ISO SHT. NO. 1933

2NSW-101 (sheet 2 of 2)  
 Lower Containment Ventilation  
 Unit 3 Supply Line

| NPS DESIGNS INC.<br>NEW YORK, N.Y.   | LIVSEY & COMPANY, INC.<br>INDIANA & MICHIGAN ELECTRIC CO.<br>DONALD C. COOK NUCLEAR PLANT |

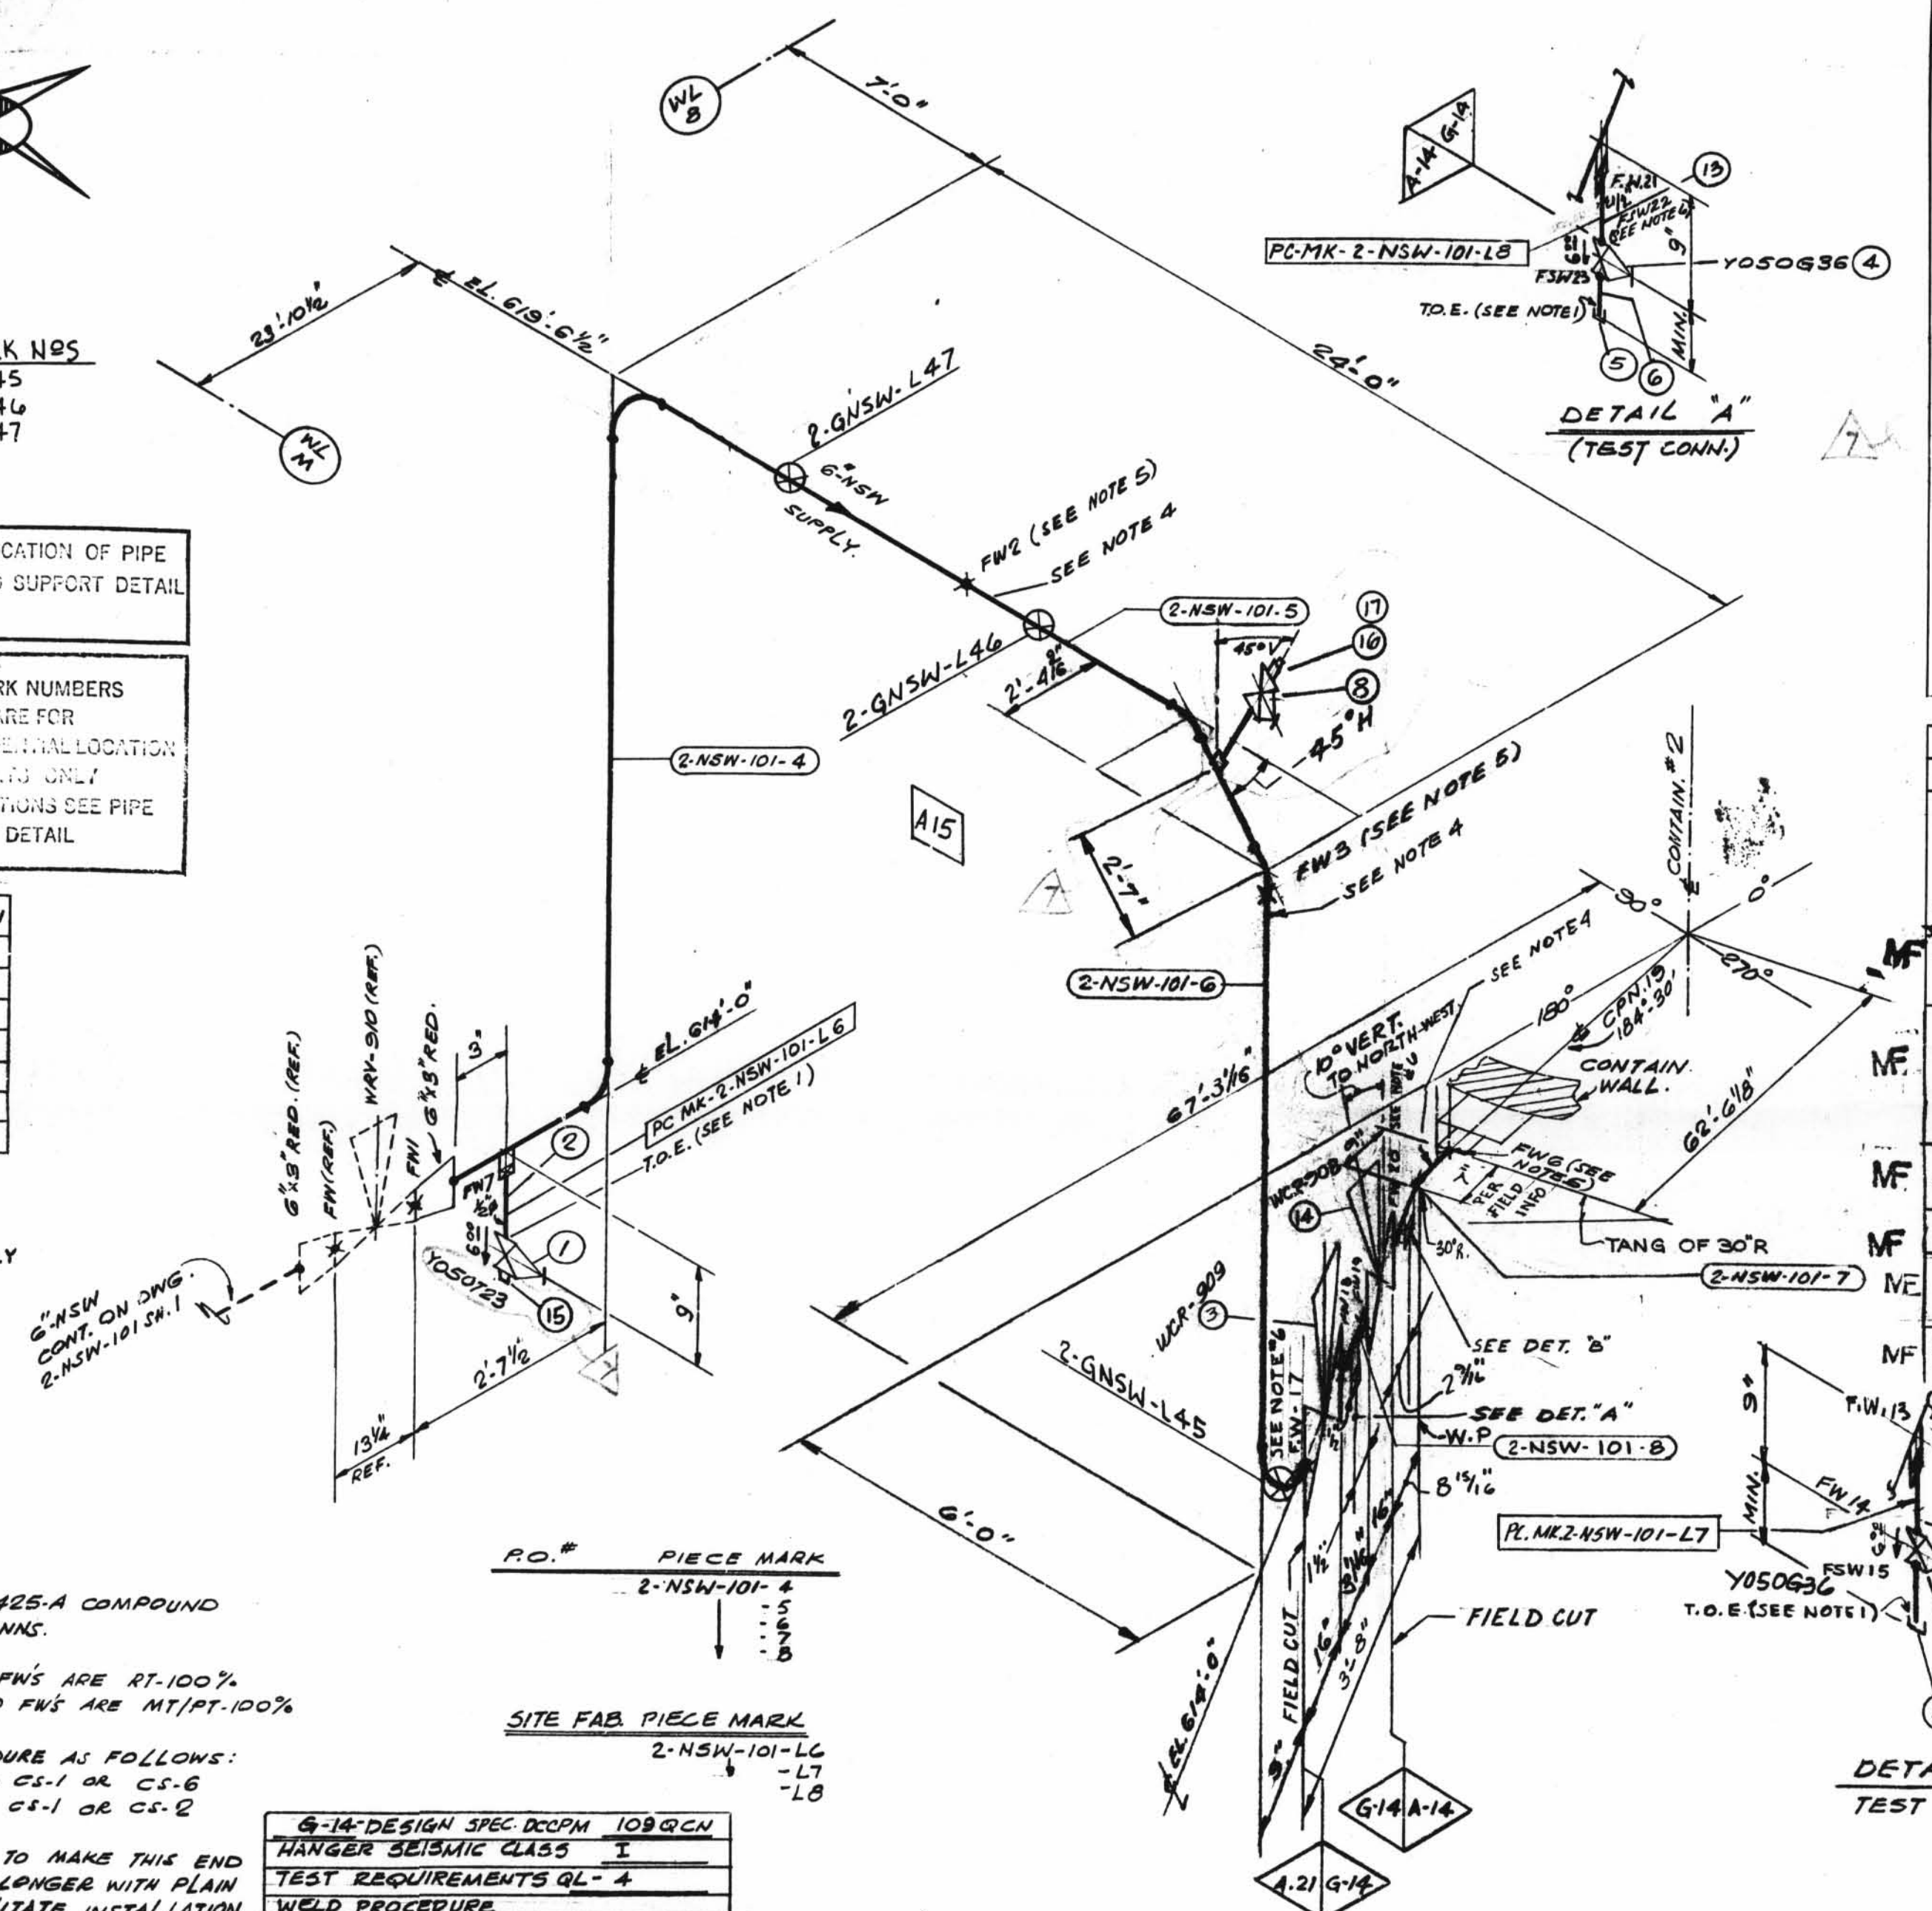
| NO. | DATE     | DR   | CHK  | DESCRIPTION  | REMARKS                |
|-----|----------|------|------|--|------------------------|
| 1   | 1/2/76   | S.A. | B.R. | REVISED BY A.E.P. DESIGN PER RFC-12-671; ADDED 6" CHECK VA. 15 C.E.O. 6A, 1/2" DRAIN VA. NO. C1-050636 1" VENT - VA. N. Y-100T23.  | ACTION REQ'D.          |
| 2   | 2/2/76   | GP   | LB   | AS PER RFC-12-1100 DELETED VALVE TAG NO. 15 C.E.O. 6A, ADDED VALVE TAG NO. C1-050636 1" VENT - VA. N. REVISED RELATED PIPING.  | FIELD ACTION REQ'D.    |
| 3   | 9/4/76   | R.F. | B.R. | PER RFC-DC-12-2549, REPLACED 6" CHECK VALVE WCR-909 WITH DIAPH. CONTROL VAIS WCR-908, 909, ADDED PIPE SPEC. A-14, WELD BOX, NOTES 6, 7, WELDS FM 17 TO 21 PER 2223 ITEMS NO. 15, 14 TO B/M. 2-N-SW-101-5 & 6 DIM. DELETED ITEMS F N. 7, 9 TO 12 FROM B/M. REV. ITEM #3 IN B/M. | FIELD ACTION REQUIRED  |
| 4   | 10/14/76 | K.A. | LB   | PER RFC-DC-12-2549 ROTATED ACTUATOR OF VALVE WCR-908 TO 10° VERT TOWARD NORTH - WEST, REVISED DIM. S.  | FIELD ACTION REQ'D.    |
| 5   | 11/1/76  | DE   | LB   | PER RFC-DC-12-2549, BOXED DIM. INDICATES FIELD INFO. 6.7" DIM. WAS 7 3/4" BY FIELD.  | NO ACTION REQ'D.       |
| 6   | 8/1/76   | D.K. | LB   | PER RFC-DC-12-2876, REV'D ITEM 8, TYPE OF VALVE. ADDED SUPPORT DETAILS SUPERSEDED HGR 150 2-GNSW-101 SHT. 2. ALL ABOVE TO REFLECT AS-BUILT CONDITIONS.   | NO FIELD ACTION REQ'D. |
| 7   | 7/1/76   | EBB  | LB   | TO REFLECT AS-FOUND CONDITIONS FOR RFC-DC-12-3010 PER FWR #750 REV. 1; ADDED PLUGS, REVISED LOCATION OF 1" VENT & B/M TO SUIT.   | NO FIELD ACTION REQ'D. |
